Br. art. 1888 600 150 i 1888 998 101

Spojnice sa ventilisanim kućištem, torzionim oprugama i sinterisanim oblogama (br. art. 1888 600 150 i 1888 998 101) zamenjuju spojnice (br. art. 1888 600 117, 1888 600 119 i 1888 634 006).

sl. 2: Spojnica, promenjena konstrukcija

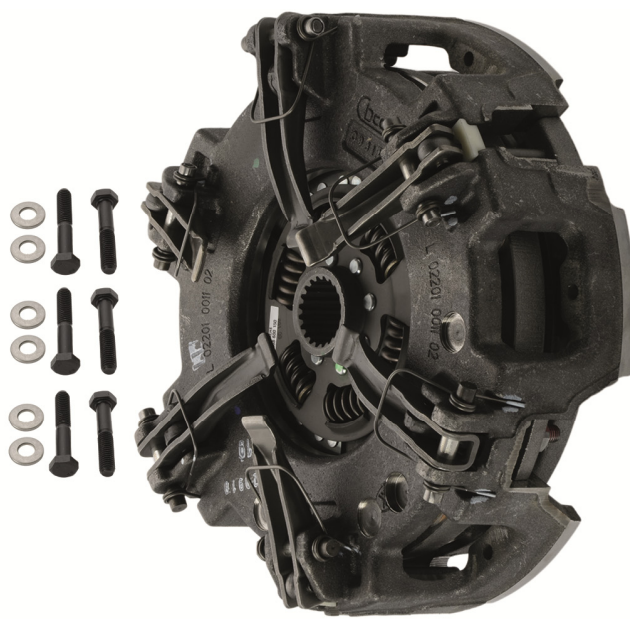
Spojnica sa ventilisanim kućištem može da se ugradi bez modifikacija zamajca.  
Komplet od šest vijaka M8x1,25x45 sadržan je u isporuci.
